PLANNING BOARD REPORT PORTLAND, MAINE

Mixed Use Development at 321 Commercial Street

Project ID 2012-615

Submitted to: Portland Planning Board Public Hearing Date: January 22 nd , 2013	Prepared by: Jean Fraser, Planner Date: January 18 th , 2013 Planning Board Report # 02-13
---	--

The two plans below compare the original submission to the final proposal:

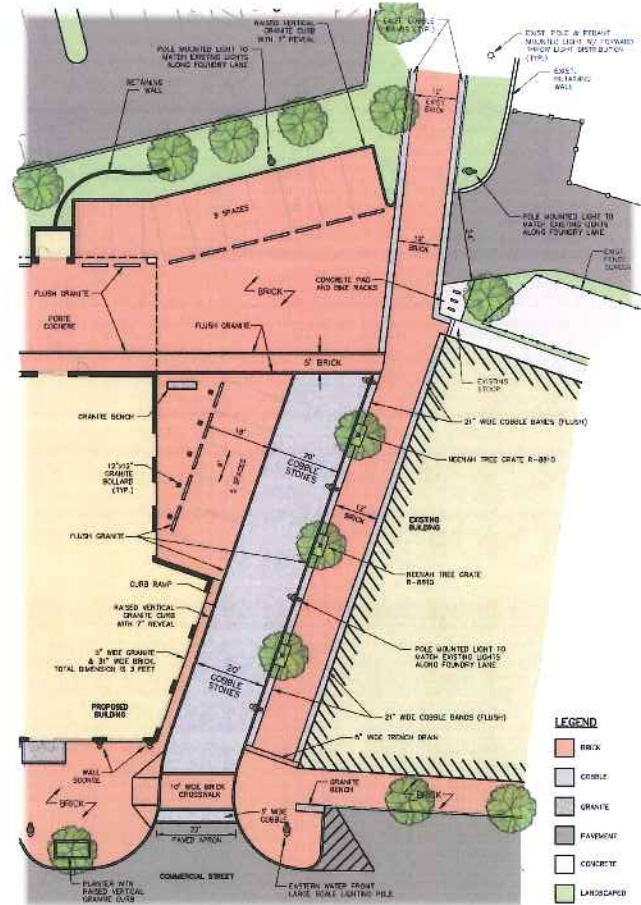
The two Workshop Memos have detailed the discussions and comments on the layout for this area, which focused on achieving a wide pedestrian walkway that continued the existing walkway, ensuring a safe integration of pedestrians and vehicles, and addressing historic preservation objectives. The final layout at right has been approved by the Historic Preservation Board on 1.16.2013 and is acceptable in terms of site plan standards.
